Edwin I. Hatch Nuclear Plant – Unit 1

Notification of Change in the Emergency Response Data System Data Point Library

This letter serves as notification of a change to the Hatch Unit 1 Emergency Response Data System (ERDS) Data Point Library drawing A-44047, per the requirements of 10 CFR 50, Appendix E, VI.3.a.

E. I. Hatch Unit 1  
NRC - EMERGENCY RESPONSE DATA SYSTEM  
DATA POINT LIBRARY A-44047 Rev. 04

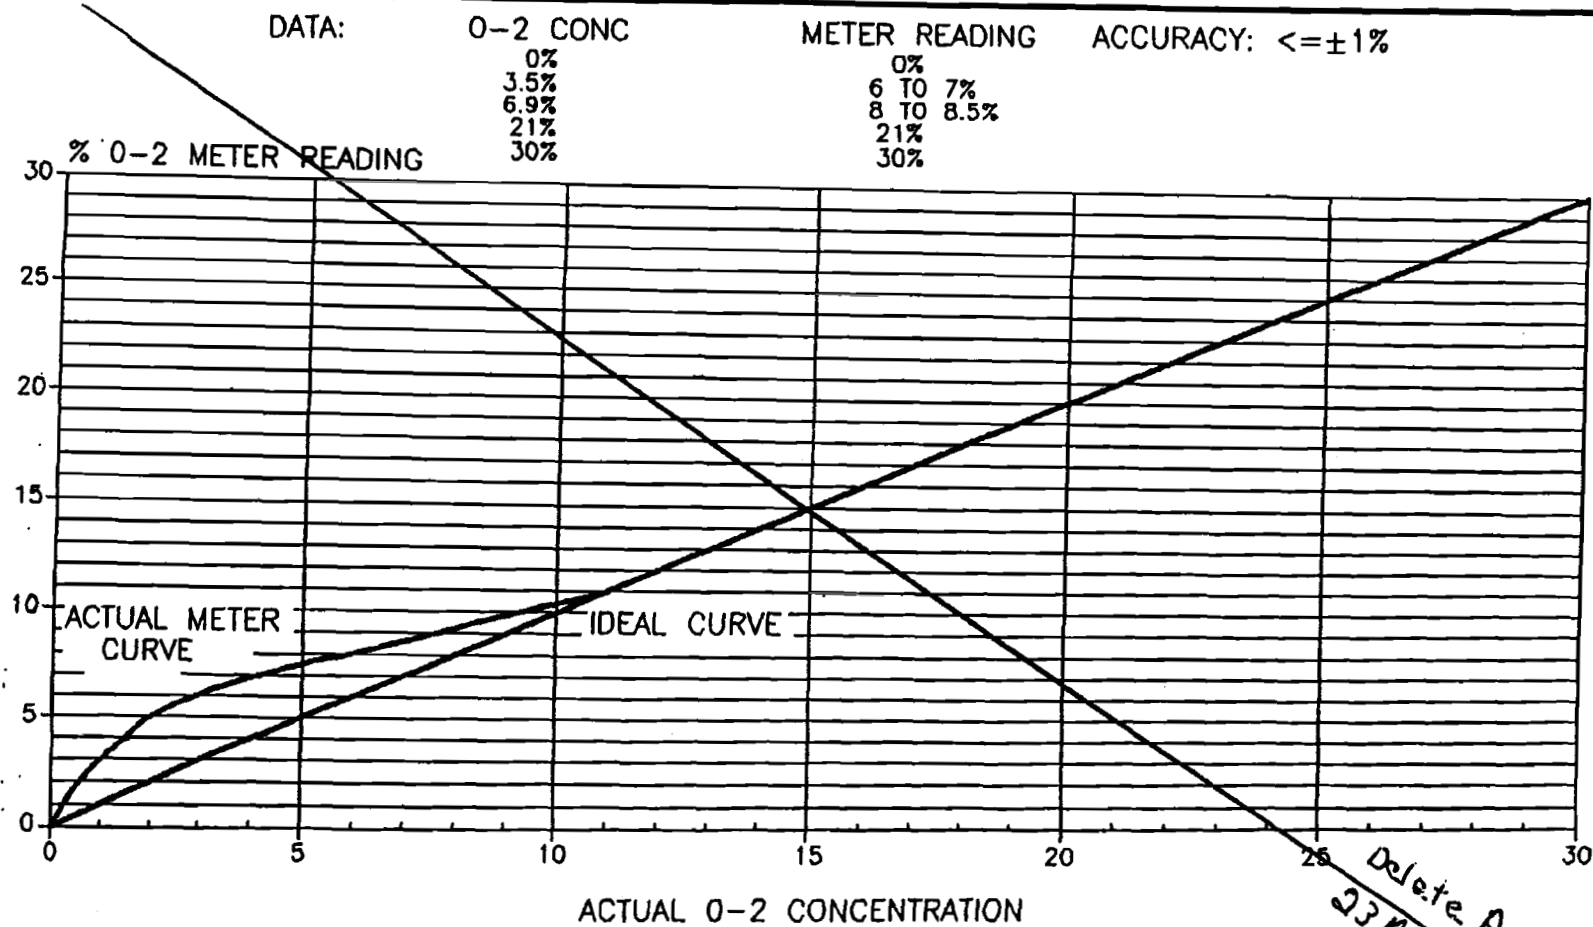
The following changes are being made to NRC ERDS parameter H2 CONC, Point I.D. H2D: The phrase "ONLY WIDE USED" is being removed from the Reference Point Notes.
